SEQUOYAH NUCLEAR PLANT (SQN) - NRC BULLETIN 88-02, RAPIDLY PROPAGATING FATIGUE  
CRACKS IN STEAM GENERATOR TUBES

Reference: NRC letter to TVA dated November 29, 1989, "Request for  
Information, NRC Bulletin 88-02 (TAC Nos. R00328/67323  
and R00329/67324) - Sequoyah Nuclear Plant, Units 1 and 2"

Attachment 1: Response to the Request for Additional Information relating to WCAP-12289, (Sequoyah Unit 1 Writeup)

Attachment 2: Response to the Request for Additional Information relating to  
WCAP-12289 (Sequoyah Unit 2 Writeup)

Figure 1

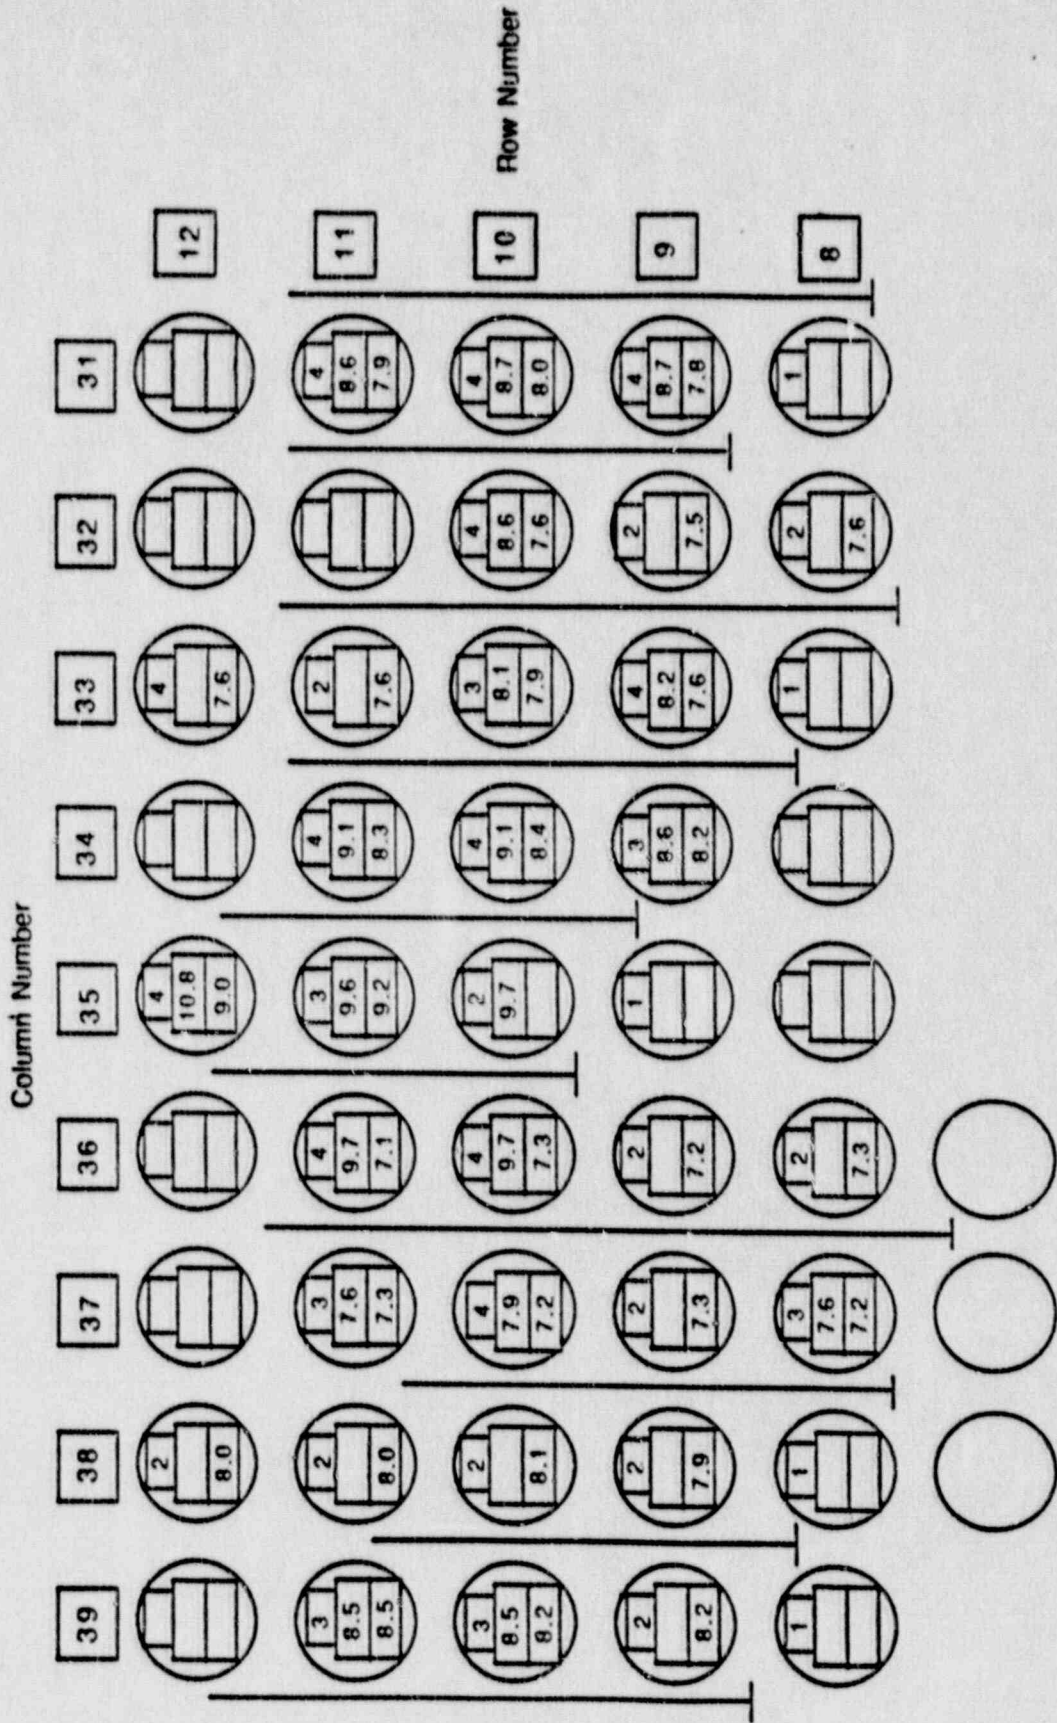
*"The staff requests...information be provided...to demonstrate that (tube R09/C35)...is acceptable for continued service."*

Response: In response to the request for additional information regarding the evaluation of tube R09/C35 in Sequoyah Unit 2 SG 2, Westinghouse has performed a detailed re-evaluation of the AVB positioning used as the basis for the flow peaking model of that tube. (See Figure 1)
